RE: PARTIAL PAYMENT APPLICATION NO. 1
INCLUDING CHANGE ORDER NO. 1 & NO. 2
CRESTBRUCK PARK SPLASHPAD IMPROVEMENTS
PROJECT NO. 116.1156.01

CHANGE ORDER FORM

Change Order Number: 2

RE: CRESTBRUCK PARK SPLASHPAD IMPROVEMENTS
ANKENY, IOWA
PROPOSAL.02

CRESTERBUCK PARK SPLASHPAD IMPROVEMENTS
REMOVE AND REPLACE ADDITIONAL PAVEMENT

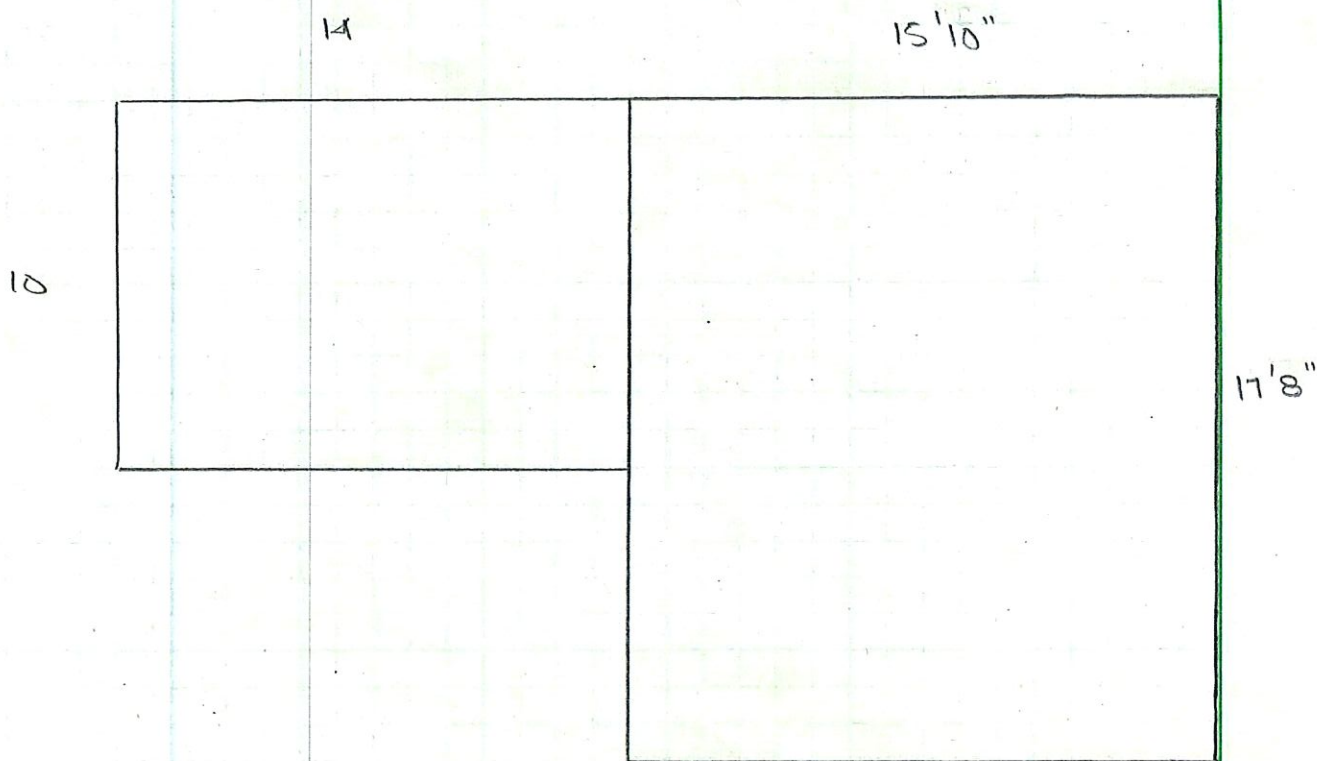
Additional pavement in the roadway needed to be removed and replaced due to proposed utility work. The existing roadway had cracking and wasn't able to be saved.

The following is a unit price summary for the additional pavement removed and replaced as directed by the City of Ankeny.

$$((14 \times 10) + (15.83 \times 17.67)) / 9 = 46.6 \text{ sq}$$
